GATEWAY REVIEW COMMISSION MEETING AGENDA

- 1.** The Commission is requested to grant Gateway approval for the proposed Southern Tire Mart located along Tri-Cities Crossing. (Weems)

To receive Gateway approval in a B-4P zone for a new Southern Tire Mart.

PERSPECTIVE VIEW - NORTHEAST ELEVATION
SCALE: NTS

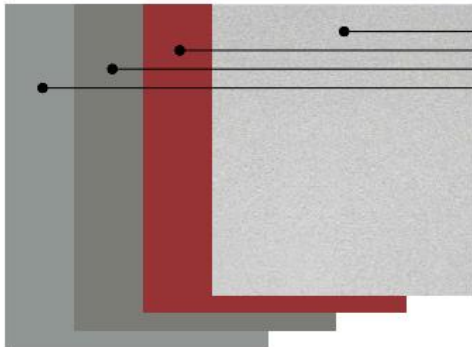
- **Architectural Design**
The building is clad in metal panels. Per gateway standards this material for cladding is required to have a waiver.

Sign Details (Wall Sign)

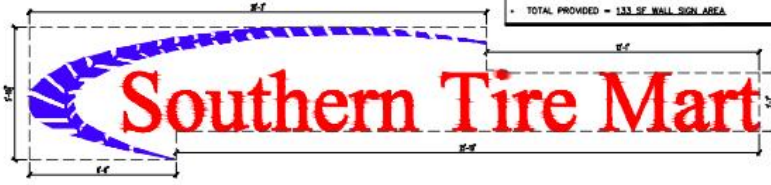
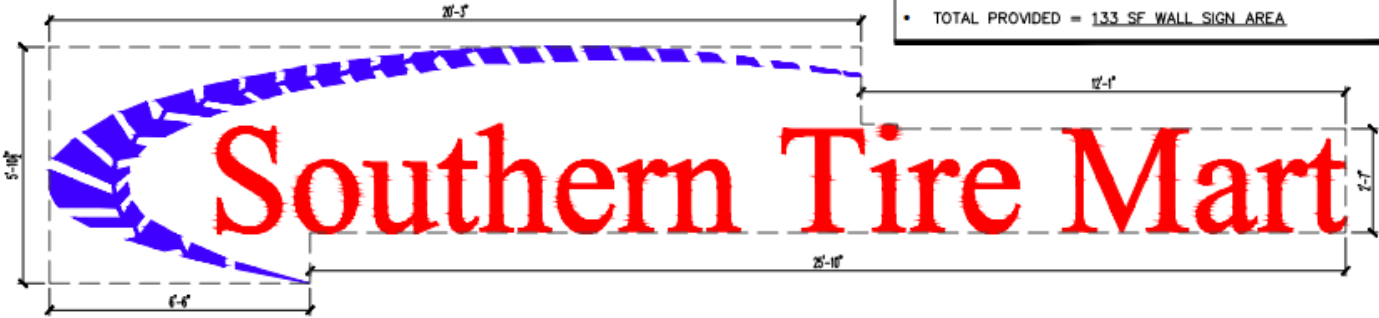
- **Site plan:** Meets zoning standards/ seeking zoning development plan approval during the 4/25 meeting of the Kingsport Regional Planning Commission
- **Landscape:** approved to the Gateway standard by the City Landscaping Specialist
- **Grading and Drainage:** Limited natural contour changes
- **Lighting and Utilities:** Sufficient to maintain light and prevent spillage.
- **Parking:** Business Service Establishment: 2 spaces per bay plus one space per employee
Required: 24; Provided: 42
- **Signage:** The wall sign proposal meets the Gateway 50% reduced standards. Allowance: 150 sq ft. Proposed: 133 sq ft.

Sign Details (Freestanding)

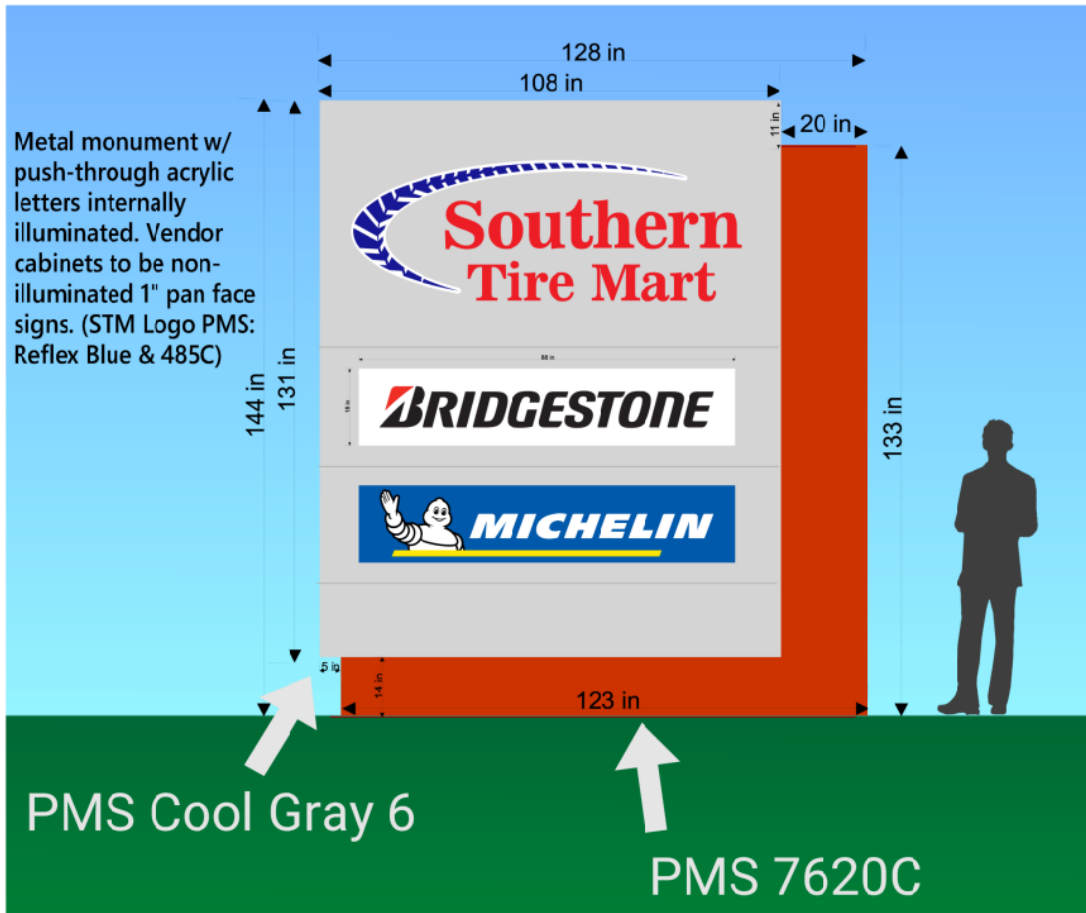
The freestanding sign is allowed to be up to 100 sq ft in size (this is the allowance after being reduced by the Gateway 50%). The proposal contains a grey colored area with sign copy that is 99.75 sq ft. The applicant has proposed the red portion of the sign to account for the monument sign base and sign frame cover, thus not counting the red to the side of the grey colored part of the sign. This interpretation is debatable for the meeting. The red portion of the sign is roughly 35 sq ft.

Staff recommends discussing the freestanding sign qualities with the applicant for a common understanding and granting subsequent Gateway approval.
